Product Change Notification - SYST-23IRS0834

ERRATA - dsPIC33CH512MP508 Family Silicon Errata and Data Sheet Clarification

dsPIC33CH512MP508 Family Silicon Errata and Data Sheet Clarification

FIGURE 1-1: I/O RAMP

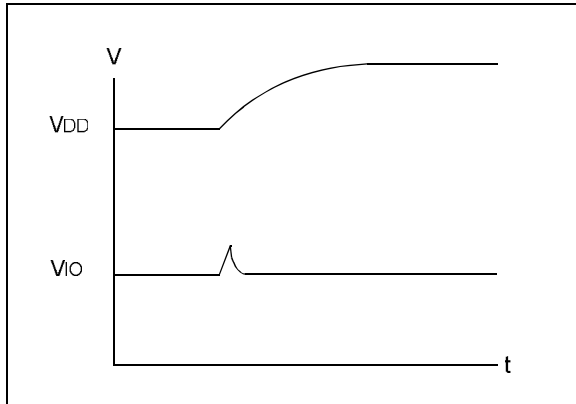
18. Module: I/O

During a fast device power-up, when the VDD ramp is less than 4 mS, the I/O pins may drive up to 100 μ A current for a duration of up to 10 μ S (Figure 1-1).

Work around

1. Slow down the VDD ramp time (greater than 4 mS for VDD to ramp 0V to 3.3V).
2. Ensure the circuitry that is connected to the pins can endure this pulse.

Example applications affected may include complementary power switches, where a transient current shoot-through might occur. High-voltage applications with complementary switches should power the high-voltage 200 μ Sec later than powering the dsPIC[®] device to avoid the current shoot-through. This behavior is specific to each device and not affected by aging.
